TOTAL PERFORMANCE VAN'S AIRCRAFT

SERVICE BULLETIN 13-12-19

Subject: Fuel Tank Attach Modification

Required Action: Install T-01220 Doublers and Upgrade T-1205 attach hardware.

FIGURE 1: SEPARATING THE DOUBLERS

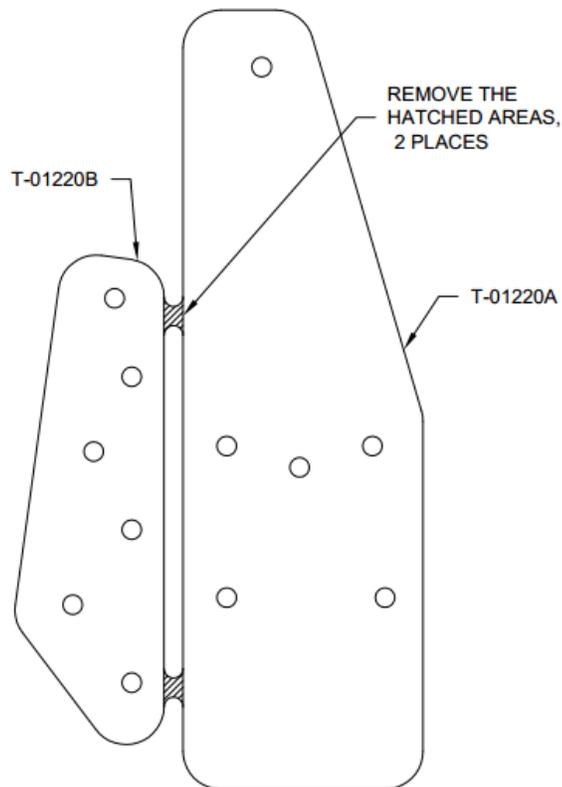
Step 4: Separate T-01220 Doubler into A & B parts as shown in Figure 1.

FIGURE 2: REMOVING INBOARD RIVETS AND NUTPLATES

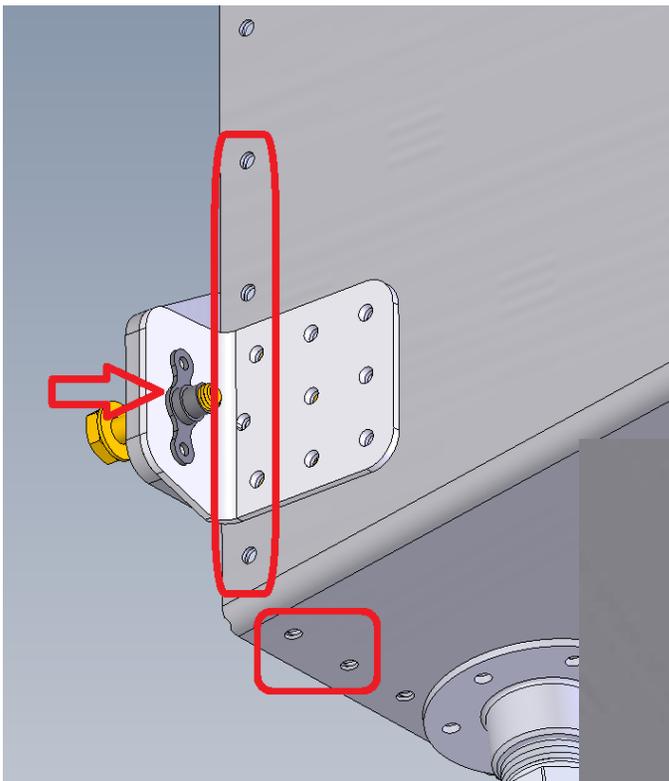
Step 5: Remove the two K-1000-3 nutplates attached to the T-1205 Fwd Tank Bracket and save them for reinstallation later (Reuse of the old nutplates is beneficial. Since they have already had a bolt inserted, the prevailing torque of the locking feature will be lower which reduces the risk of over torquing and fracturing the frangible bolt). Removal of the rivets common to the doublers and other rivets depicted will greatly help with the removal process of the existing sealant. See Figures 2 and 3. See KAI Chapter 5 for further information on removing rivets.

FIGURE 5: INSTALLING THE DOUBLERS

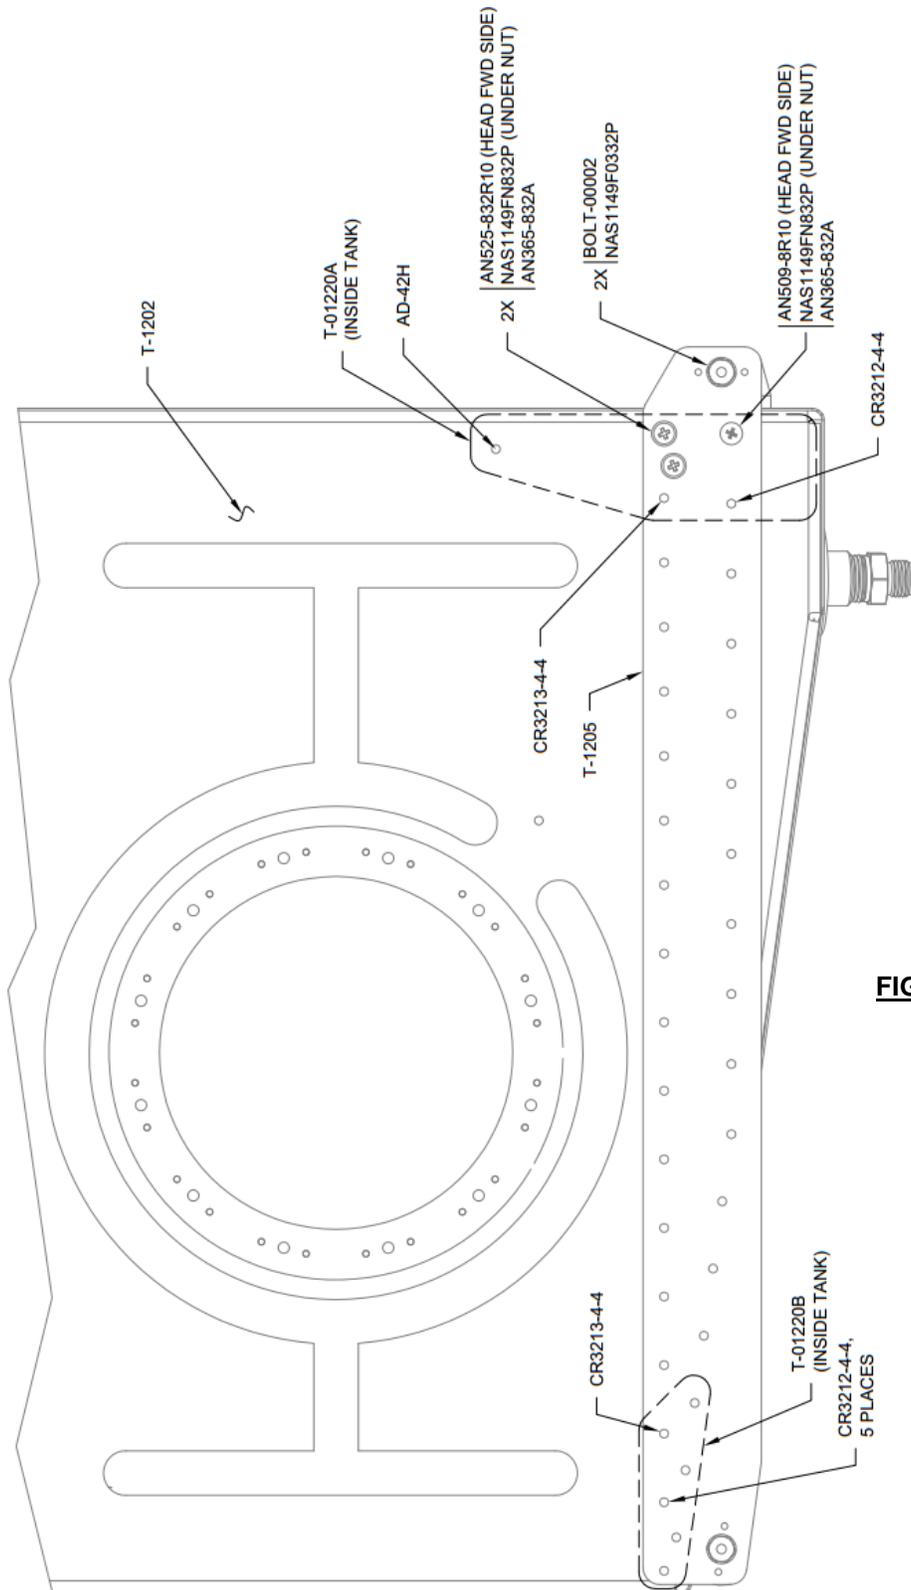
Step 8: Test fit the doublers inside the tank. Radius the edges of the doublers to fit against the bend radii in the T-1202 Fwd Tank Bulkhead. See Figure 5.

Step 13: Add a very thin layer of sealant covering the face of the doublers that will lay against the T-1202 Fwd Tank Bulkhead. Using the hardware callouts shown in Figure 5 rivet the doublers to the tank structure using tank sealant. Refer to Section 5 for installation of Cherry Max rivets.

Step 14: Install the screws common to the inboard doubler as shown in Figure 5.
